**DEPARTMENT OF HEALTH**  
Contested Case Hearing Re Red Hill Permit Application  
19-UST-EA-01  
Supplemental Testimony of Curtis Stanley

1           This supplemental testimony was prepared in response to the Written Testimony of  
2   Nicole M. DeNovio (“Dr. DeNovio”) and the report incorporated into that testimony entitled  
3   “Evaluation of Hydrology, Groundwater Flow and Contaminant Fate and Transport,” both of  
4   which are dated December 29, 2020 (collectively, the “DeNovio Testimony PDF”).  
5   Dr. DeNovio’s report and testimony contain errors that lead to incorrect conclusions regarding  
6   site conditions and environmental protectiveness. The details related to the Navy’s review of  
7   Dr. DeNovio’s report and associated inaccuracies are provided in Table 1. This table is formatted  
8   to describe particular issues noted in her report along with a brief response describing errors and  
9   other concerns. The following testimony addresses these errors to show that:

2 **Figure 1:** The complete data set for TPH-d concentrations over time in RHMW01, 02, and 03

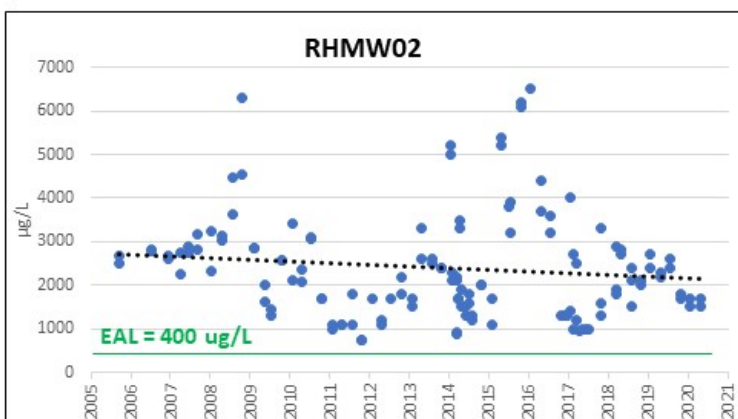
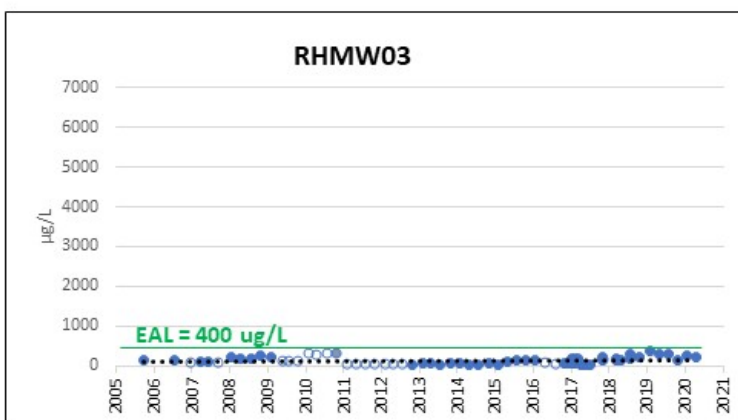
8           Dr. DeNovio states that "Groundwater sampling concentrations from monitoring wells in  
9           the heart of the Facility show statistically significant trends for total petroleum  
10          hydrocarbon middle distillates (TPH-d) from 2015 to present,"<sup>1</sup> and the attached report  
11          also states that "trend analysis indicates the potential for ongoing impacts" to the  
12          aquifer.<sup>2</sup> Table 2.2-1 of the report tabulates 24 trend analyses of partial data sets, only  
13          one of which showed an upward trend. Dr. DeNovio states that this single trend "is  
14          inconsistent with wide-spread biodegradation of historical fuel releases or fuel released in  
15          2014."<sup>3</sup> The full environmental dataset, however, shows that ever since groundwater  
16          monitoring began in 2005, the near-tank wells have either stable or decreasing

3 The analyses presented in Table 2.2-1 and Figures 2.2-11 and 2.2-12 of Dr. DeNovio’s  
4 report are based on a cherry-picked subset of the environmental data that does not reflect  
5 the long-term trends evident in the complete dataset. As shown on Figure 1, below,  
6 analyses of the complete TPH dataset for the three wells near the tank farm clearly  
7 indicate decreasing concentration trends in RHMW02 and RHMW01 over the course of  
8 the monitoring program and a flat trend in RHMW03. Figure 1 also shows that  
9 concentrations in RHMW03 have always been less than the environmental action level  
10 (EAL),<sup>4</sup> and concentrations in RHMW01 have consistently been below the EAL since  
11 2008.

**RHMW01:**  
TPH-d concentrations show an overall decreasing trend over time.

No detections above the EAL after 2008.

**RHMW02:**  
TPH-d concentrations have varied with an overall decreasing trend over time.

This is the only well in the monitoring network in which concentrations typically exceed the EAL.

**Figure 2. COPC Detection Ratio.**

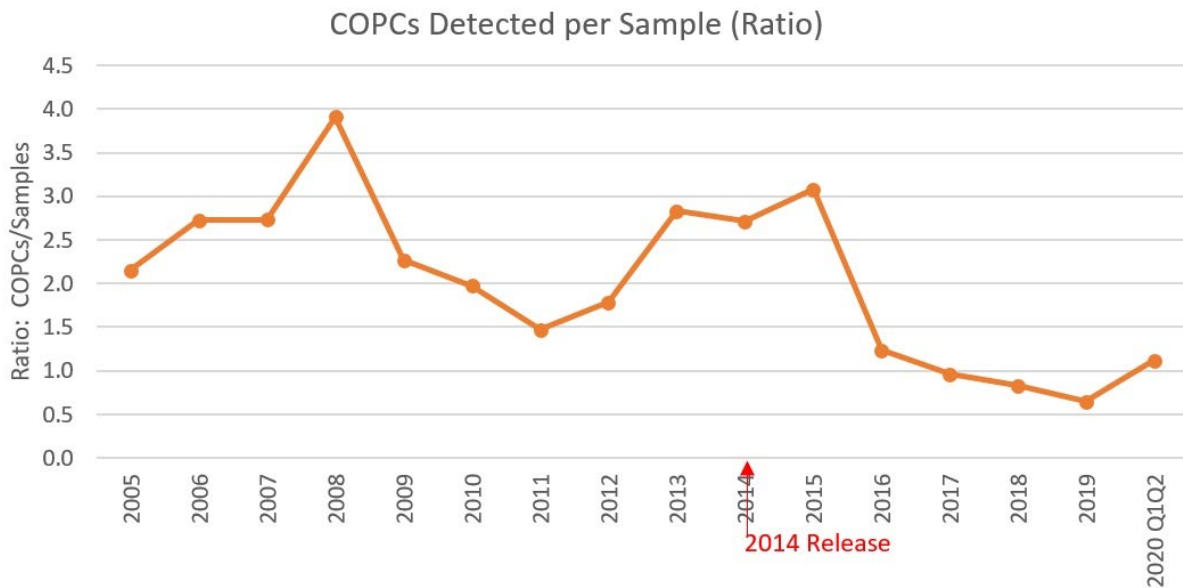
1 Dr. DeNovio states that “the documented 2014 fuel release corresponds to increases in  
2 fuel constituents observed in groundwater,”<sup>8</sup> referencing Figure 2.2-4. This slide does not  
3 account for the significantly increased sampling of RHMW02 that occurred after the  
4 2014 release (increasing from 8 COPC samples in the year prior to the release to 23  
5 COPC samples in the year after the release). Since RHMW02 (and other near-tank wells)  
6 is where most of the COPCs and other analytes have been detected, of course the number  
7 of detects would go up significantly since the wells with the detects were being sampled  
8 more frequently after the release. This is not a result indicative of trends in groundwater  
9 concentrations, rather is attributable to increased sampling of wells with known detects.  
10 Relatedly, and to the contrary, the chemistry lines of evidence described in the CSM

11 demonstrate that the 2014 release did not impact groundwater. As can be seen on Figure  
12 2, below, the normalized ratio of detects per sample indicate a modest range of variability  
13 over the years, likely associated with the use of multiple labs. This figure also depicts a  
14 modest rise in the ratio prior to the 2014 release in 2013 (when there was no fuel in Tank  
15 5). In 2014, the ratio decreases and then goes back up in 2015. This range of modestly  
16 elevated ratios in the 2013 – 2015 time period is actually lower than other observed ratios  
17 in the past and again is likely due to the use of multiple labs over time which conduct  
18 TPH analyses in a slightly different manner between labs resulting in different results for  
19 the same sample.

**Figure 3:** Summary of Groundwater Monitoring Results Demonstrating Delineation of Groundwater Impacts

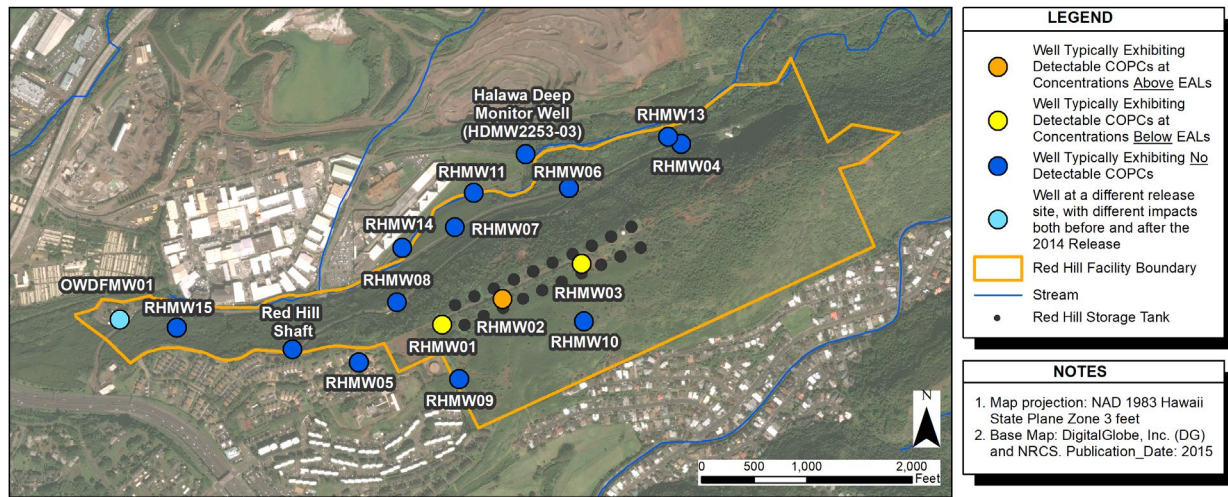
Dr. DeNovio characterizes the groundwater monitoring well network as “sparse” and the monitoring wells as improperly constructed. However, the well network is sufficiently dense to demonstrate that impacts to the groundwater are confined to the area immediately below the tanks, and the construction of the wells conforms to DOH guidance. As Figure 3, below, shows, monitoring well RHMW02 is the only monitoring well that consistently exhibits detectable concentrations of petroleum “chemicals of potential concern” (“COPCs”) at concentrations exceeding EALs. The two monitoring wells closest to RHMW02, and in close proximity to the tanks (RHMW01 and

1 RHMW03) are less impacted, typically exhibit detectable concentrations of COPCs at  
2 concentrations less than EALs, and the detectable concentrations are comprised of mostly  
3 polar material, indicative of naturally occurring biodegradation. All the other  
4 groundwater monitoring wells (the perimeter wells surrounding the tank farm), including  
5 the nearby drinking water well, normally do not have detectable levels of fuel-related  
6 analytes.<sup>9</sup> The Navy continues to plan additional expansions to the groundwater  
7 monitoring well network, after expanding it from 6 monitoring wells in 2013 to 19 in  
8 2020 (with an additional 8 wells planned in the near future). We also note that DOH  
9 reviewed and approved the locations and construction of the wells installed by the Navy.  
10 Although Dr. Denovio suggests that more wells might be desirable in the immediate  
11 vicinity of the tank farm, early discussions with the regulators during AOC scoping

**Figure 4:** Dimensions of conventional groundwater monitoring well screens installed in the unconfined basal aquifer.

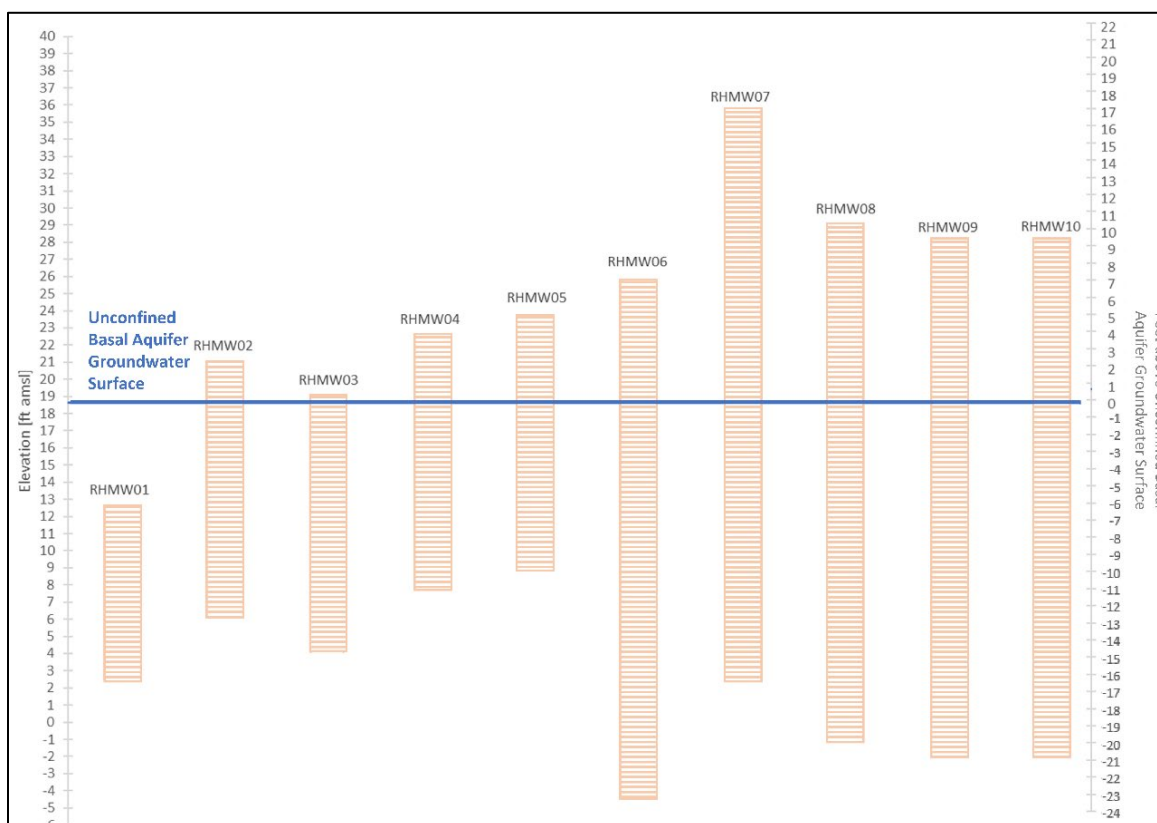
1 Dr. DeNovio also erroneously states that the wells have “short screen intervals” and  
2 therefore may not detect LNAPL.<sup>12</sup> DOH recommendations state that: “The maximum  
3 recommended screen length is typically 10 feet. The screen length should be kept as short  
4 as possible to accomplish the required task.”<sup>13</sup> Figure 4, below, shows the dimensions of  
5 the conventional monitoring well screens installed in the unconfined basal aquifer, all of  
6 which exceed DOH’s 10-foot recommendation to help assure that the screen interval  
7 would intersect the water table during different pumping conditions. These well designs  
8 were reviewed and approved by DOH prior to installation. Although RHMW01 does not  
9 intersect the water table under current pumping conditions, the Navy is planning to  
10 replace this well with a new well appropriately constructed so that the screen intersects

Dr. DeNovio questions the reliability of data from “2-inch monitoring wells.”<sup>10</sup> These wells conform to DOH guidance: “Typical well diameters for environmental investigations are 2 to 4 inches, depending on the objective of the well installation (e.g., site investigation [typically 2 inches] or groundwater remediation [typically 4 inches]) and the proposed monitoring and test equipment. When practical, the casing diameter should not exceed 4 inches....”<sup>11</sup> Wells at the site range from 2 to 4 inches in diameter, as recommended by DOH.

**Figure 5:** The impacted soil vapor monitoring wells described by Dr. DeNovio were located far above the groundwater aquifer, in the area within the rock's holding capacity.

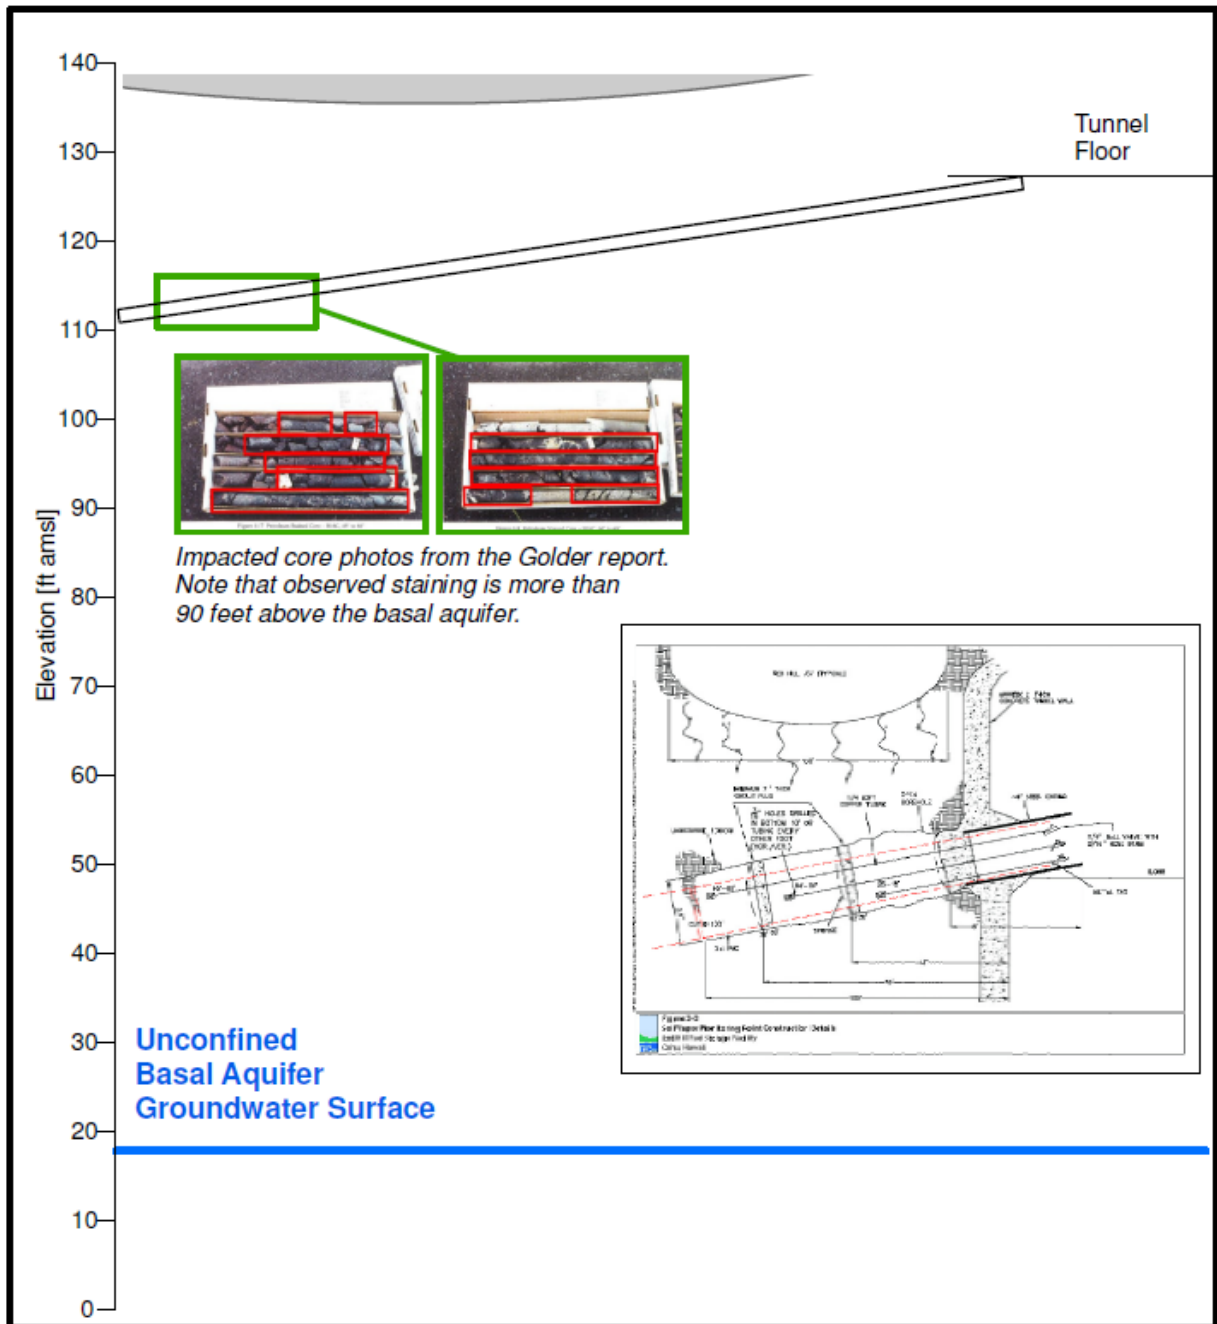
1 reaching the Sole Source Aquifer.”<sup>16</sup> The Navy has never pretended there aren’t impacts  
2 to the groundwater below the tanks. As can be seen in the FER, the Navy never stated  
3 that the holding capacity “prevents” migration of fuel; rather, the holding capacity  
4 undoubtably “helps to impede” downward migration, which allows additional time for  
5 the measured NSZD to occur. Importantly, Dr. DeNovio’s own statements in other  
6 sections of her report bolster the fact that the geologic formation is capable of holding  
7 released petroleum. Dr. DeNovio’s Figure 2.2-5 contains direct evidence that petroleum  
8 was retained in the basalt when the soil vapor monitoring wells were installed  
9 immediately below the tanks. As shown on Figure 5, below, these cores selected by  
10 Dr. DeNovio are located in precisely the near-tank area where many different analyses  
11 confirmed that fuel is being held and subject to natural source-zone depletion (“NSZD”)

have migrated to the groundwater. To put this in proper perspective, Figure 5, above,  
shows the relevant dimensions. Bore logs and core samples collected from groundwater  
monitoring wells indicate that areas of the subsurface between the vapor wells and the  
groundwater did not have the kinds of impacts observed in the near-tank soil vapor  
monitoring wells. Moreover, the Navy has clearly described the presence of LNAPL in

**Figure 6.** Dr. DeNovio's alternative NSZD calculation did not account for the largest component of carbon dioxide flux, which flows into the Facility tunnels.

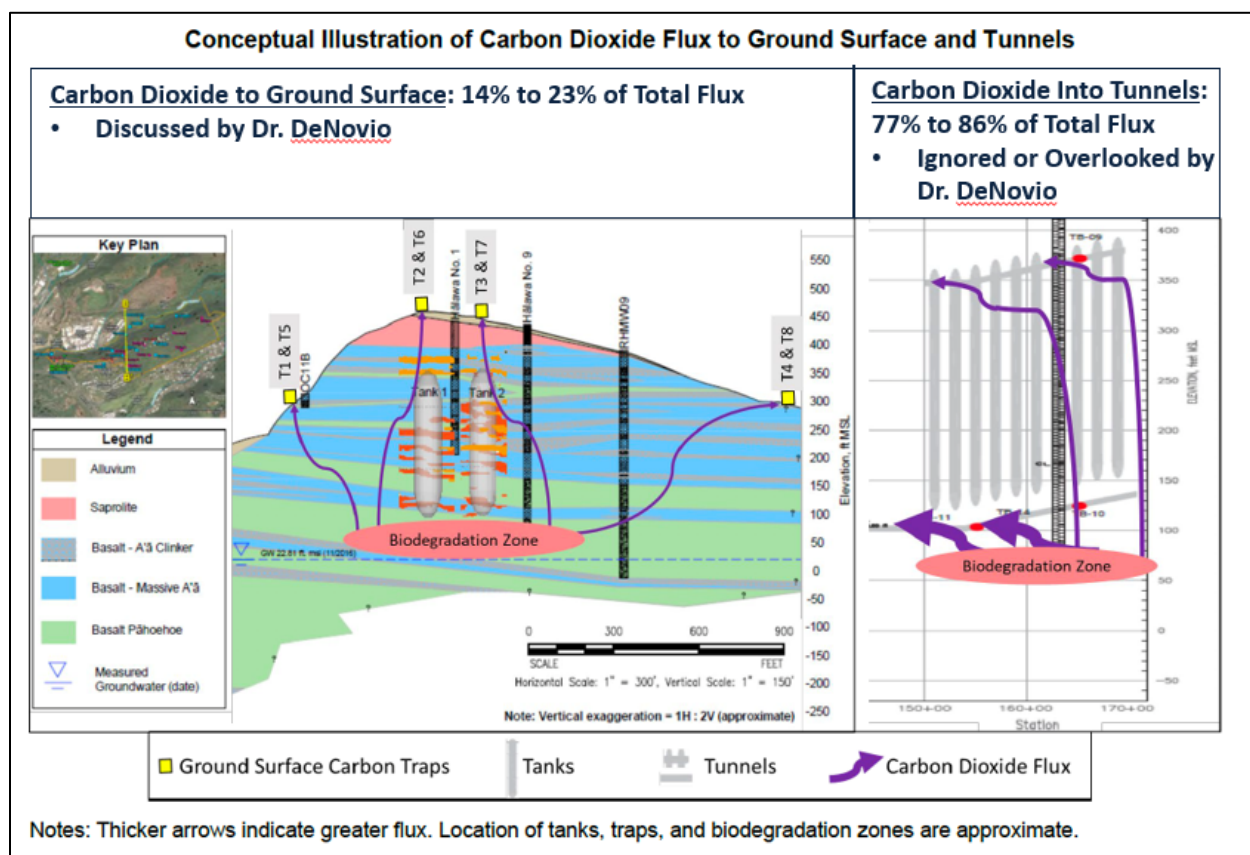
3 For the carbon dioxide flux data, Dr. DeNovio conducted an alternative calculation that  
4 only considers one of the two components of the carbon dioxide flux: that measured at  
5 ground surface. The larger component of carbon dioxide flux is measured entering the  
6 Facility tunnel system, as illustrated on Figure 6, below. The tunnel ventilation system  
7 draws in air from the surrounding soil and rock, which includes carbon dioxide generated  
8 by NSZD. The tunnel is much closer to the NSZD zone than the ground surface is. Thus,  
9 the flux entering the tunnel system represents far more NSZD (3,400–6,400 gallons per  
10 year) than the surface flux component (1,000 gallons per year). Dr. DeNovio's report  
11 does not present any alternative calculations of the tunnel component, omitting it.

9 Dr. DeNovio’s alternative calculations of NSZD rates are based upon at least three errors.  
10 The Navy measured the rate of NSZD at the Red Hill Facility using two independent  
11 assessment methods: i) carbon dioxide flux and ii) temperature. These two methods yielded  
12 similar estimates for the rates of natural petroleum depletion at the Facility: 4,400–7,400  
13 gallons per year for the carbon dioxide flux method and 2,600–17,300 gallons per year for  
14 the temperature method. Although neither method can provide a precise measurement of  
15 the depletion rate at the Facility (which has inherent natural variability), both methods  
16 demonstrated that natural depletion is occurring within an estimable range. Furthermore,  
17 the overlap of and general similarity between the two ranges of estimated depletion rates

**Figure 8.** Average PID readings from the soil vapor monitoring well network documenting the attenuation of historical petroleum releases.

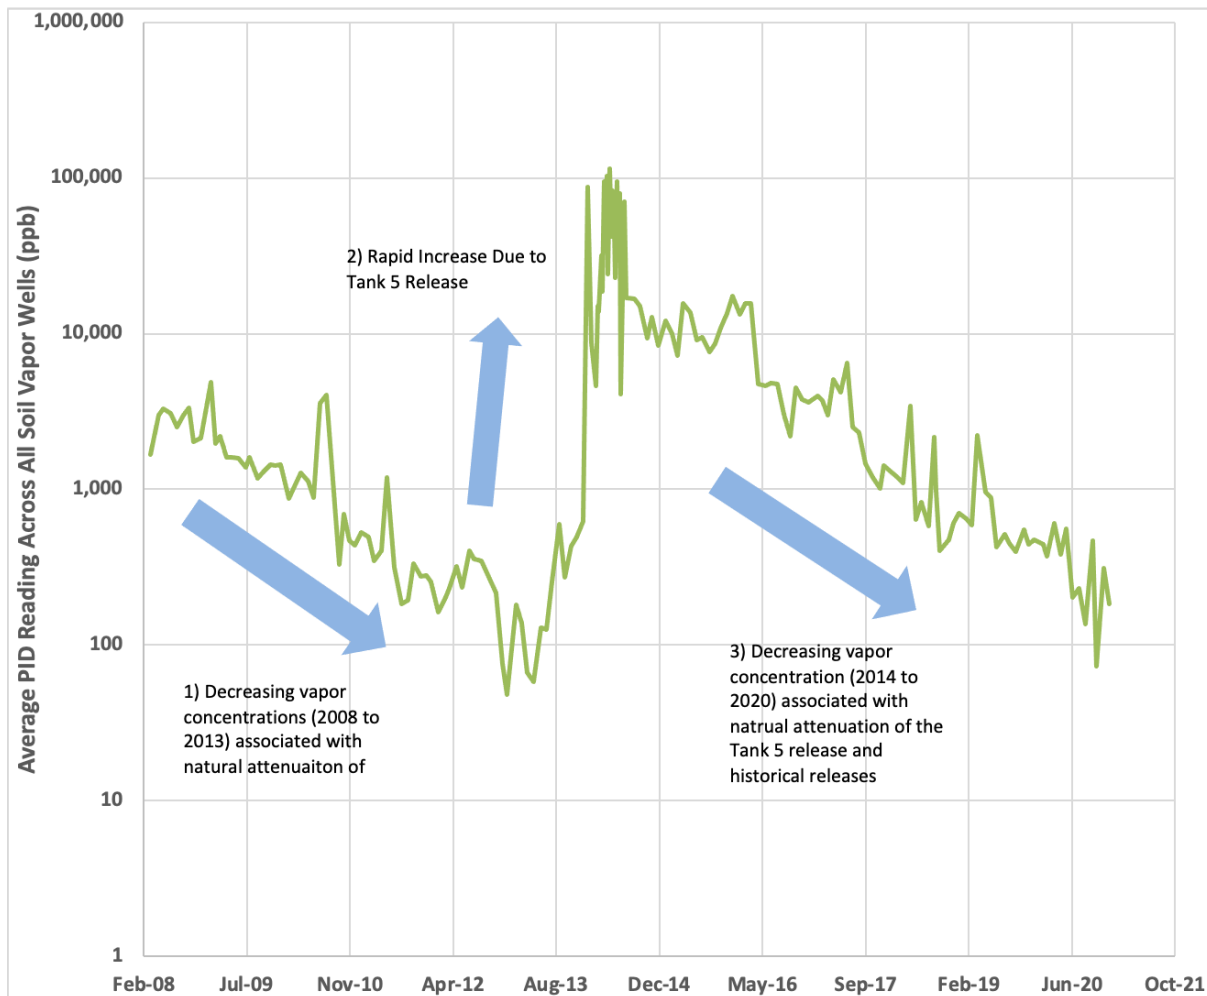
11 Dr. DeNovio's report uses a logarithmic scale, which hides differences in the reading  
12 between the tanks. Figure 9 in this response provides a to-scale depiction of the large  
13 differences in readings between Tank 5 and adjacent tanks.)

In addition to release detection, the soil vapor monitoring results have improved understanding of the formation's holding capacity and the NSZD of historical petroleum releases. As shown on Figure 8, below, the average PID readings across all monitoring points demonstrate decreasing petroleum vapor concentrations during the early years of monitoring from 2008 to 2013, which is consistent with the natural attenuation of historical releases. Petroleum vapor concentrations increased significantly in early 2014 due to the Tank 5 release, but have decreased from 2014 to present, which is consistent
